60 Whitfield Street

Proposed Elevation -
South East Face

60WS-A-SBA-DR-XX-4013-C3

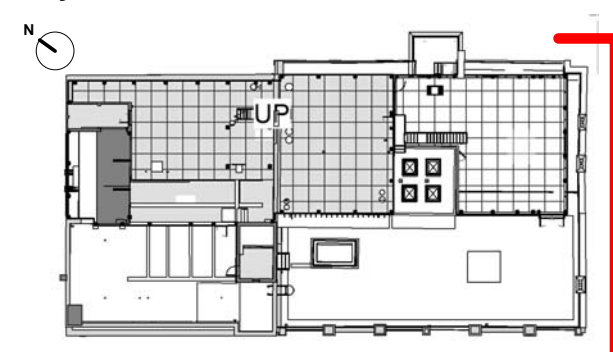
- Louvre added to enclose MEP
- Existing enclosure of Goldbeaters atrium is retained except two lateral walls
- Scope of demolition of existing plant room on Walport building increased
- Minor repositioning of approved flues
- Maintenance cat ladder added to link Goldbeaters terrace with Walport terrace
- Amended stair-landing levels
- Parapet of dumbwaiters enclosure raised by 235mm
- Reduced louvre height to match Howland Mews elevation
- One section of window removed
